ADDENDUM #1

DATE: NOVEMBER 11, 2021

LEE HILLS HALL - RENOVATE SPACES FOR NOVAK LEADERSHIP

PROJECT NUMBER: CP220031

REFLECTED CEILING **DEMOLITION PLAN**

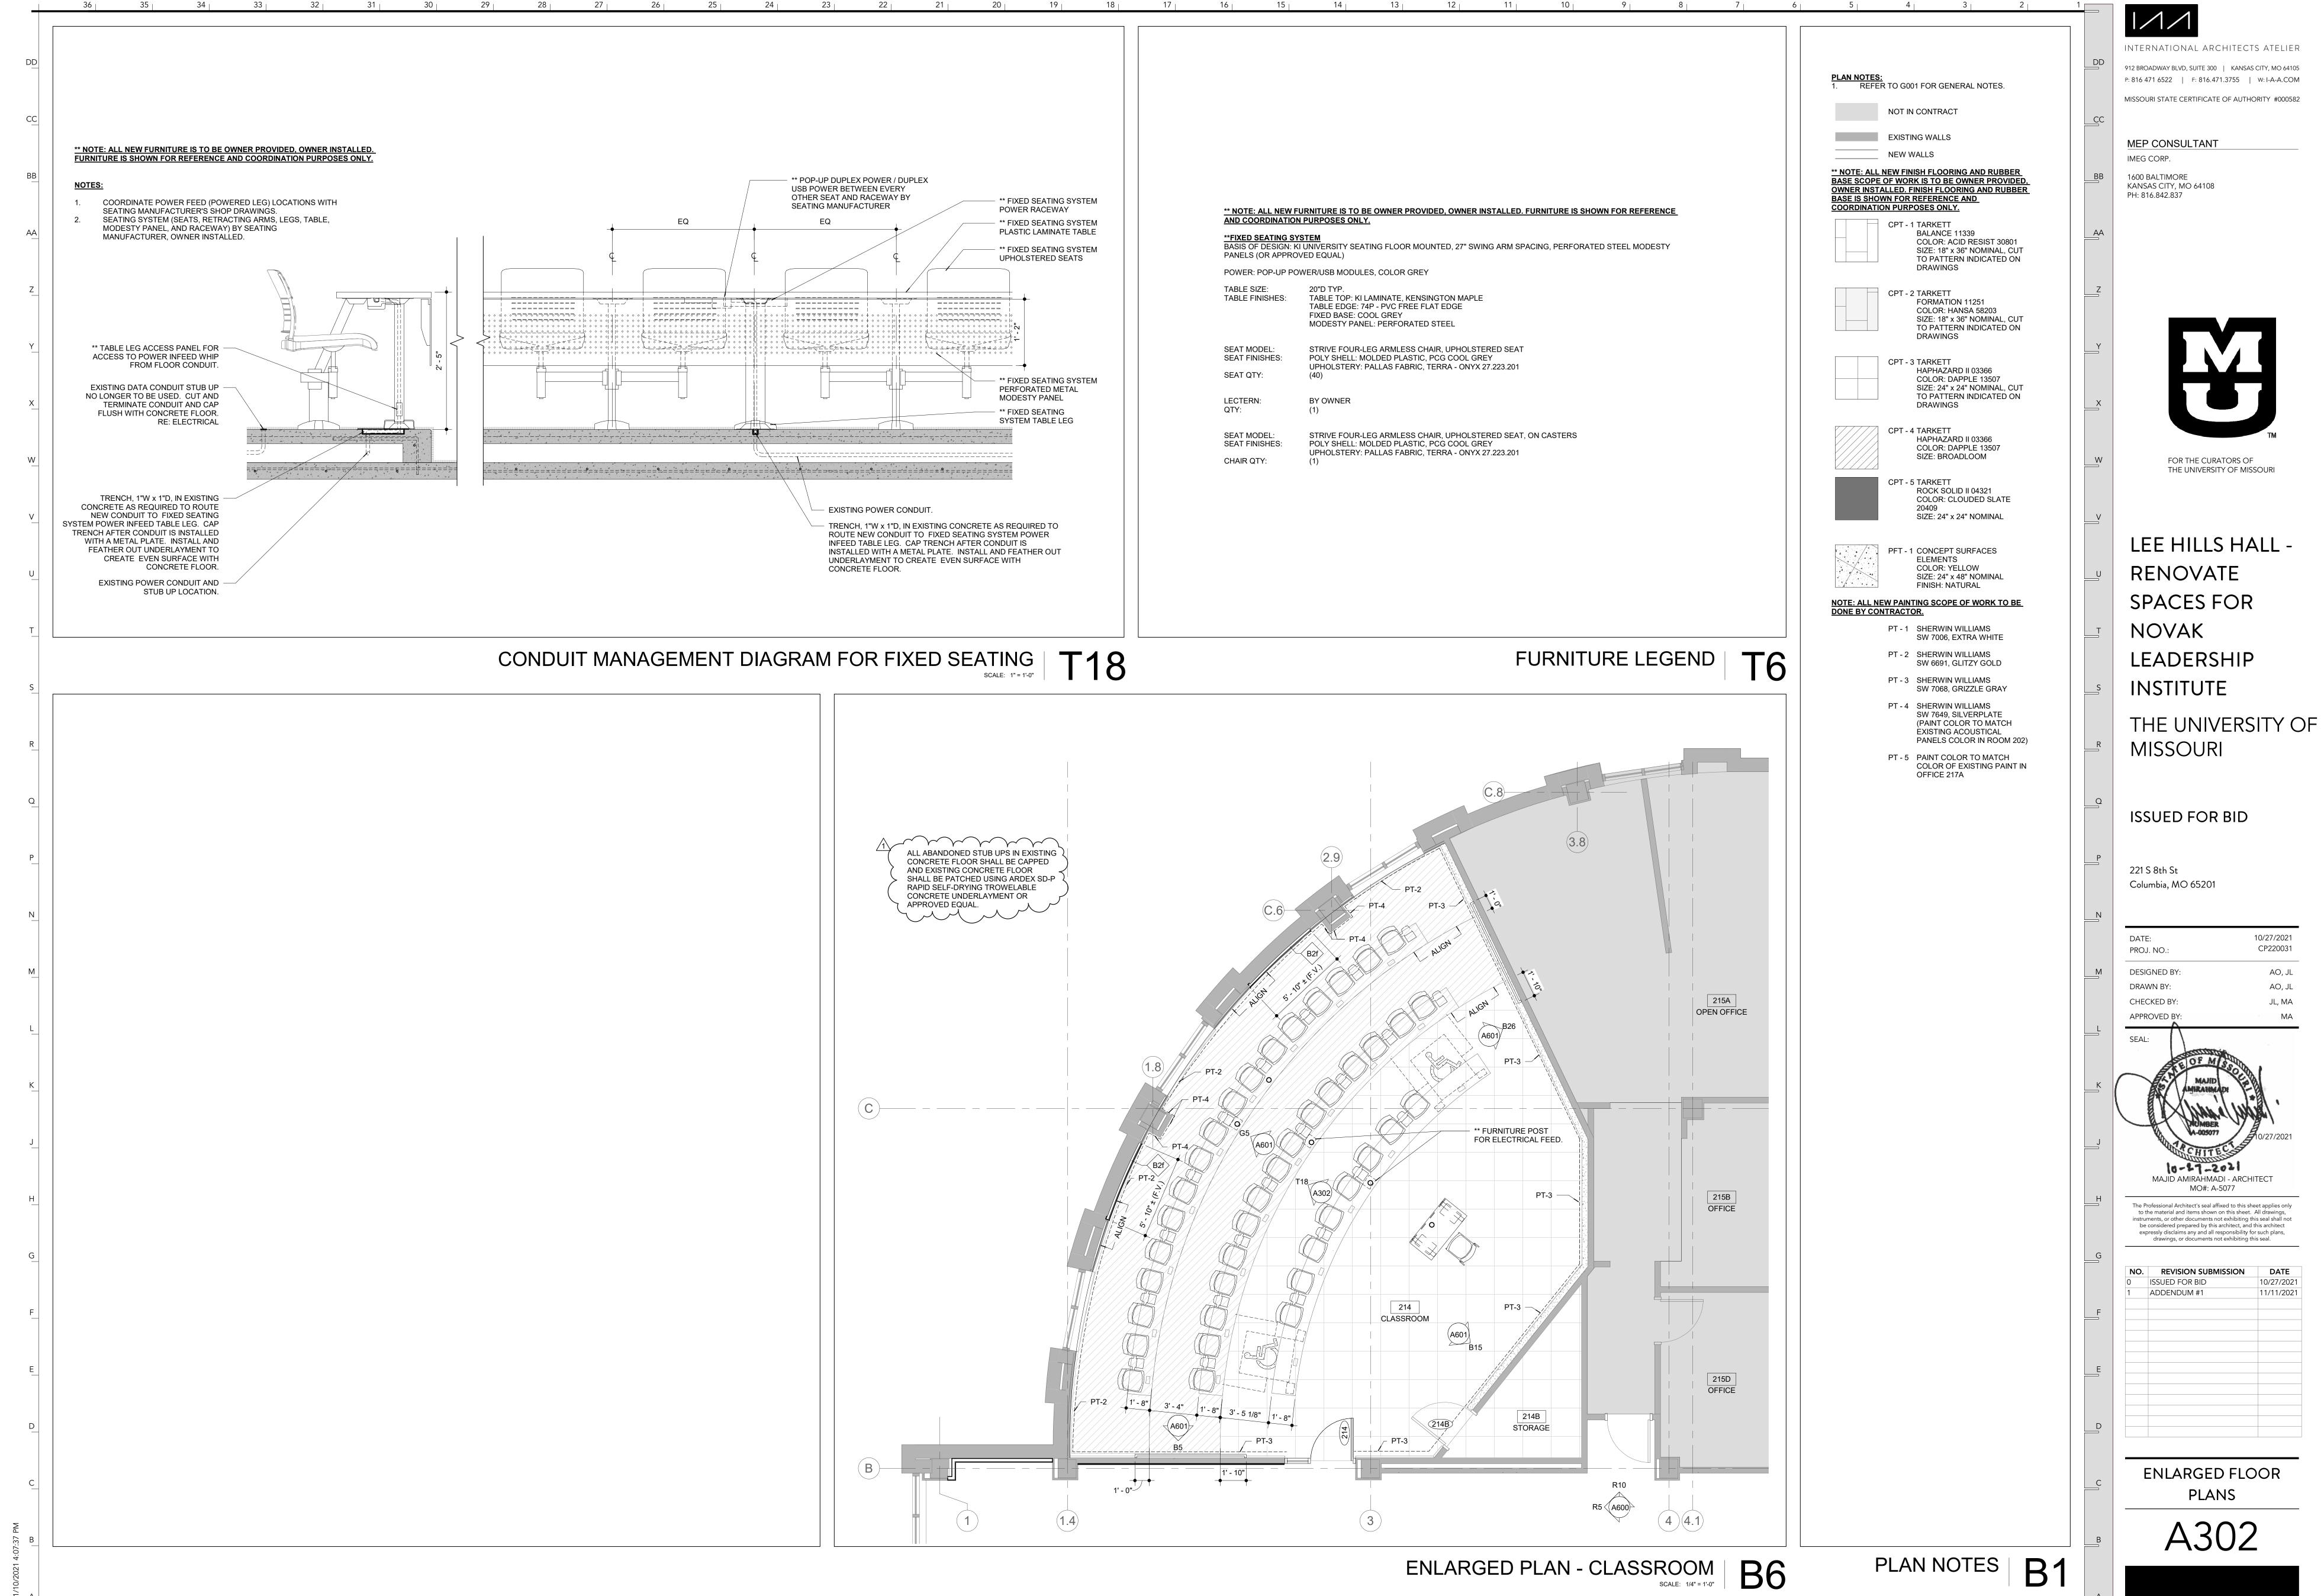
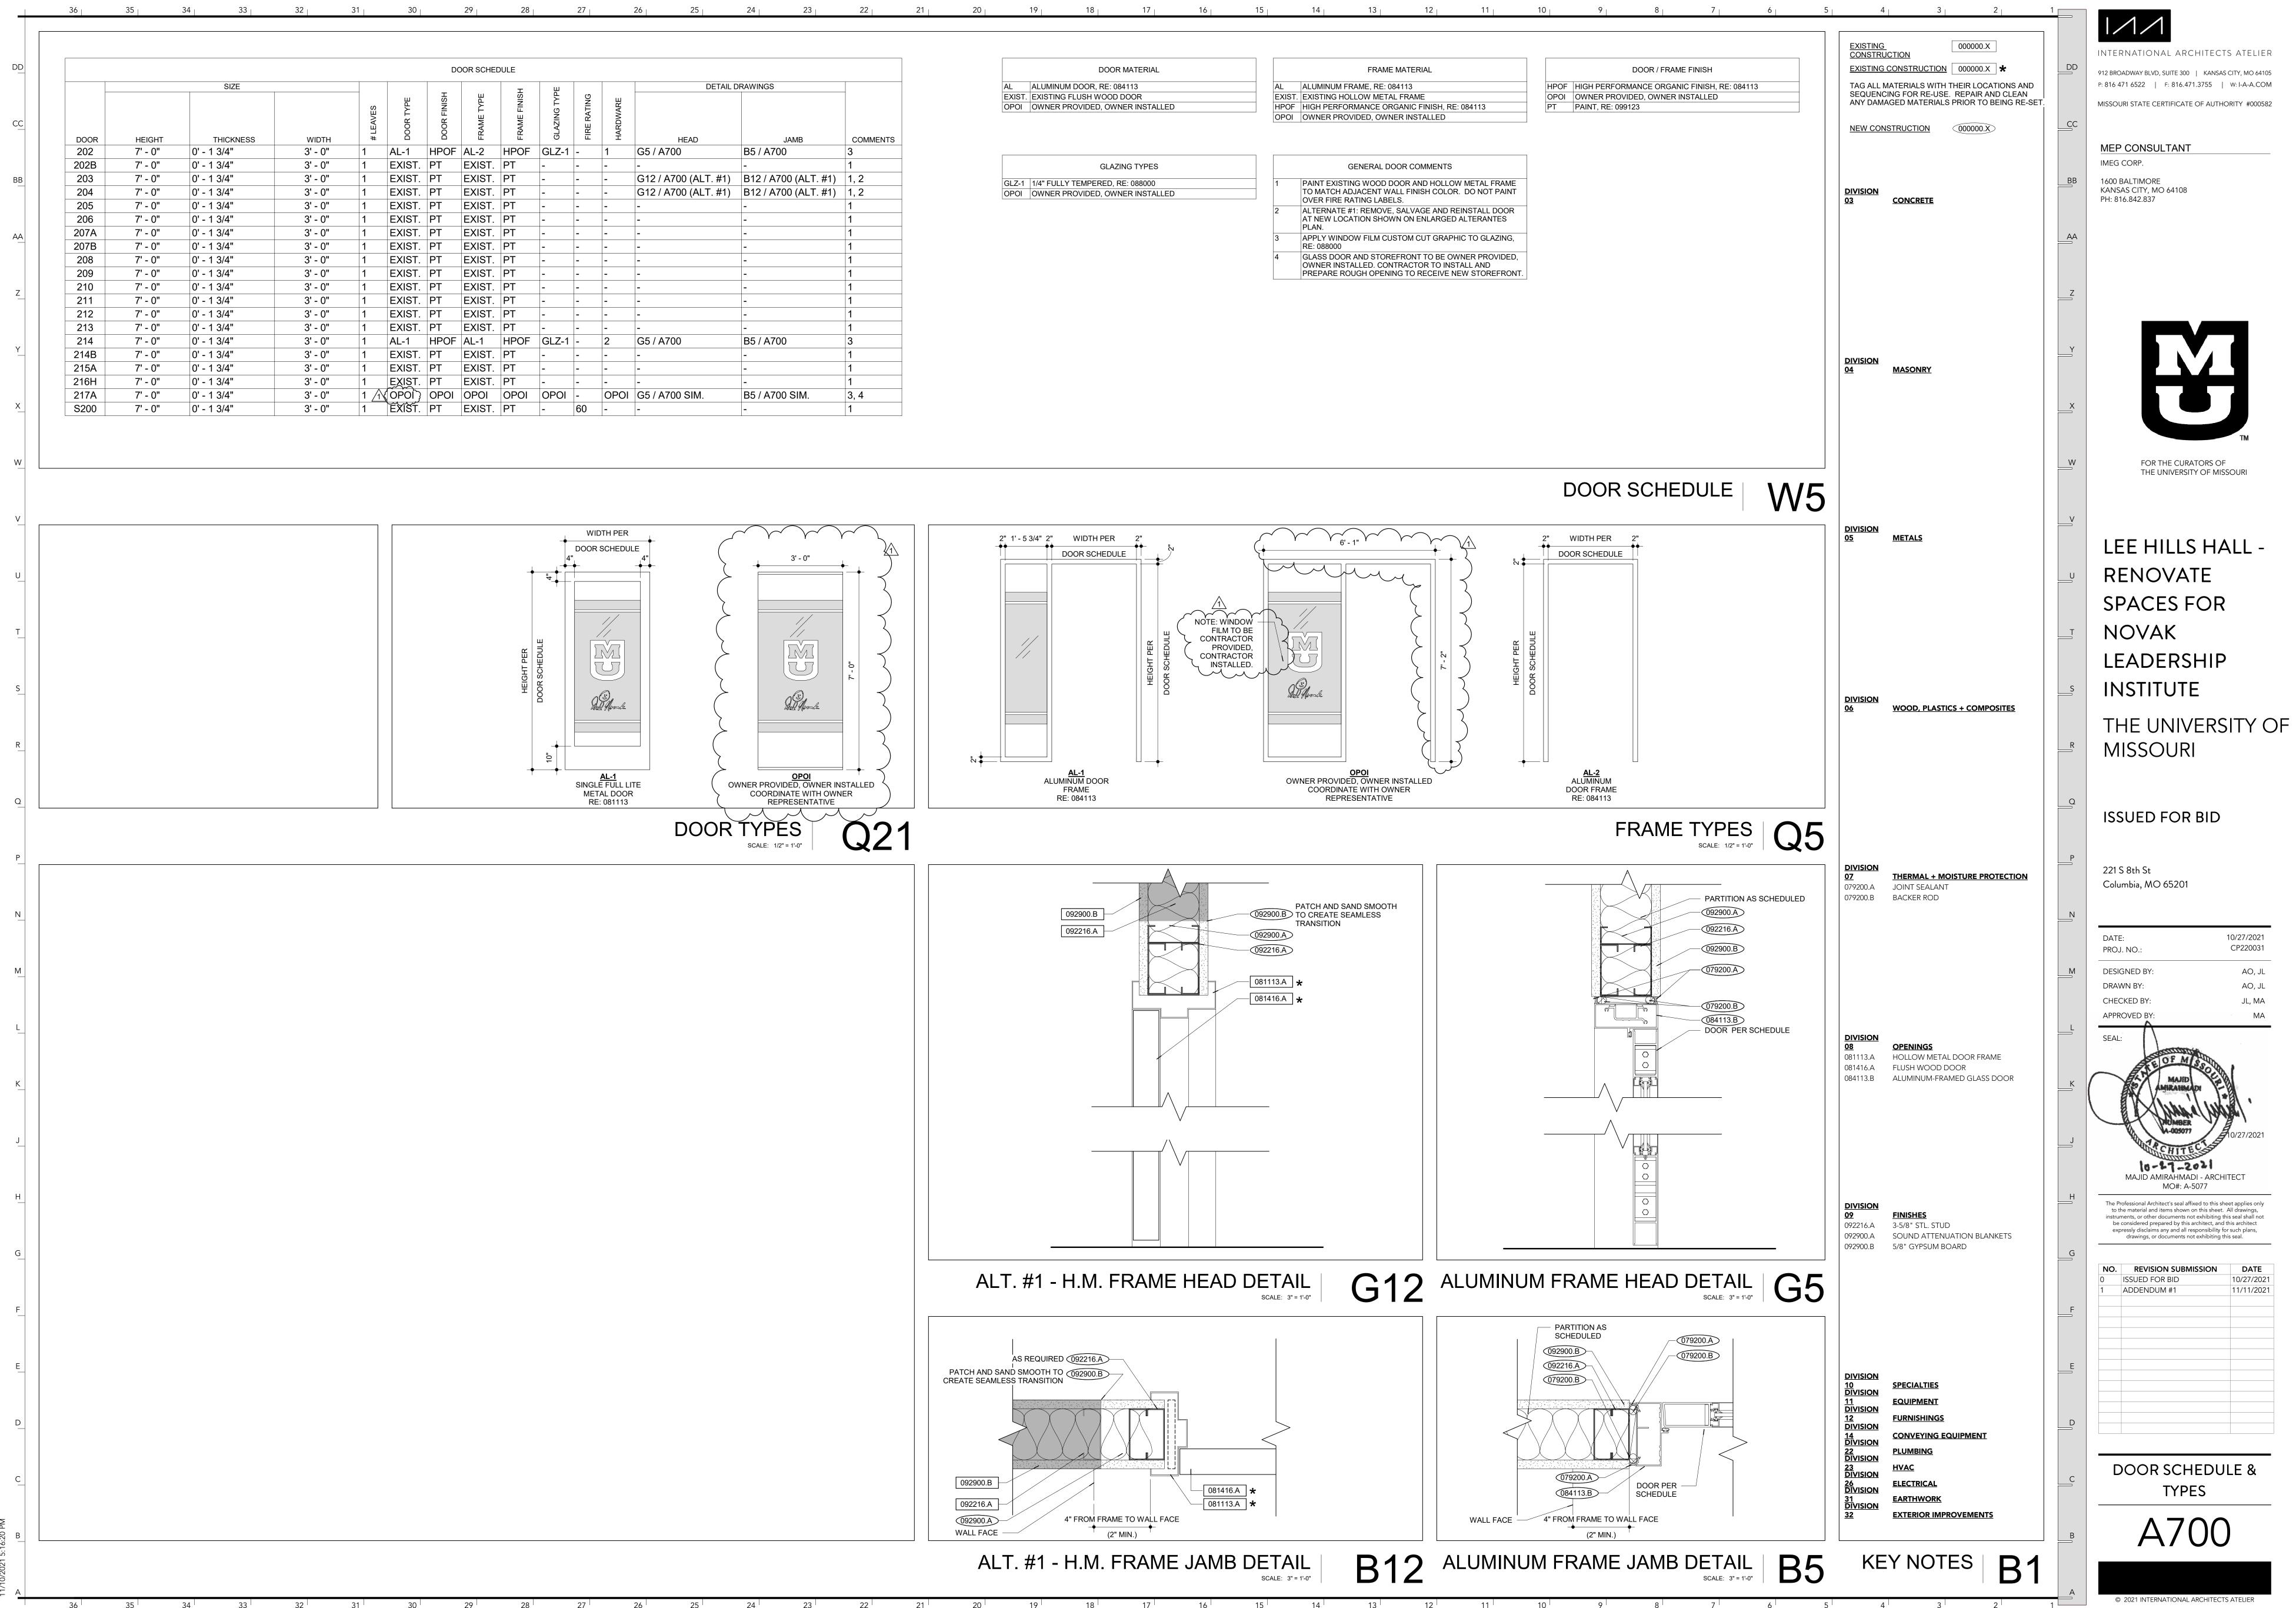
1. <u>Drawing Sheet: D400 – REFLECTED CEILING DEMOLITION PLAN</u>

ADD: Enlarged Ceiling Demolition Plan – Classroom 121

REMOVE: Note #35

REPLACE WITH: Core drill existing floor slab for new power and data conduit stub up.

Coordinate with owner exact location for connection with lectern provided

by owner. Neatly cut portion of existing gypsum board ceiling in Classroom 121 below as required for access to install conduit. Install new gypsum board and patch and paint to match adjacent surfaces. Scope of work to be done between 12/18/2021 and 1/17/2022 while the

classroom is not occupied. Re: Elect.
